UNITED STATES PATENT AND TRADEMARK OFFICE

APPLICATION NO.	FILING DATE	FIRST NAMED INVENTOR	ATTORNEY DOCKET NO.	CONFIRMATION NO.
10/790,796	03/03/2004	Toshiki Sugawara	520.43590X00	4358

Office Action Summary	Application No.		Applicant(s)	
	10/790,796		SUGAWARA ET AL.	
	Examiner		Art Unit	
	Patrick J. Connolly		2877

DETAILED ACTION

FIG. 6

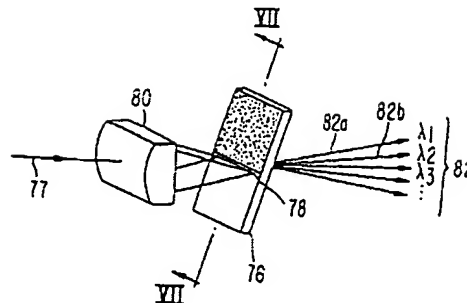
As to **claim 1**, Shirasaki teaches a spectroscopic device including (see Figures 6 and 18 below):

a parallel interference spectrometer having a chromatic dispersion characteristic (Figure 6 corresponding to VIPA 230 in Figure 18);

As to claim 2, Shirasaki discloses a focusing lens (Figure 6, 80) and a parallel interference plate (76) coated with a first reflecting film having a boundary with light input plane on one surface of a transparent substrate, on the other surface of the transparent substrate, second reflecting film having reflection factor being smaller than that of said reflecting film is formed, and said dispersive device is arranged so as to diffract light passed through said second reflecting film (see Figure 6 above, Figure 7, column 5, lines 50-67 and column 6 lines 1-39).

As to claim 4, Shirasaki discloses said parallel interference spectrometer has a focusing lens part and a parallel interference plate, said parallel interference plate has, on one surface of transparent substrate, an input plane to which light from said focus lens part is inputted, and first reflecting film having a boundary with said input plane, on the other surface, second reflecting film having reflection factor being larger than that of a said reflecting film, said dispersive device is arranged so as to diffract light passed through said first reflecting film and so as to output diffracted light on a side of said parallel interference plate (see Figure 6, 18, analysis with respect to **claims 1-3** above).

FIG. 18

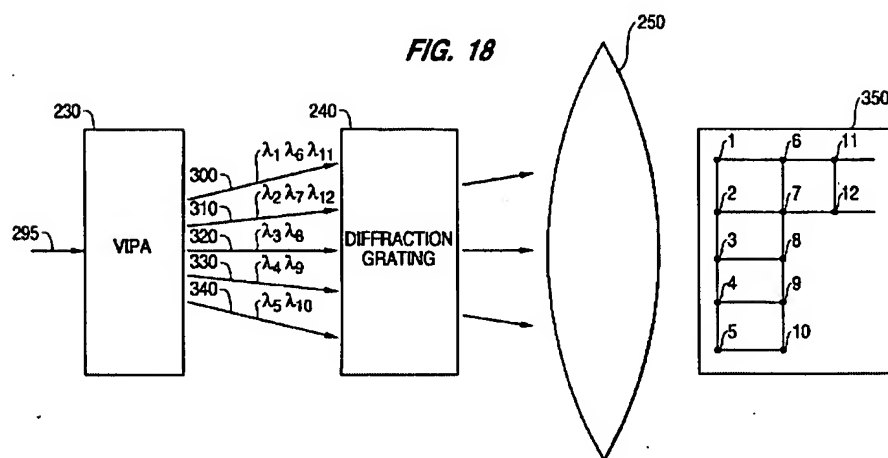
a dispersive device having chromatic dispersion characteristic smaller than that of said spectrometer (Figure 18, diffraction grating 240, see also bottom of column 15, lines 62-67 and column 16, lines 1-11);

wherein the spectrometer and the dispersive device are arranged at a predetermined distance from each other (see Figure 18 above, the elements are static and thereby at a predetermined distance);

As to **claim 8**, Shirasaki discloses a diffraction grating (see Figure 18 above).
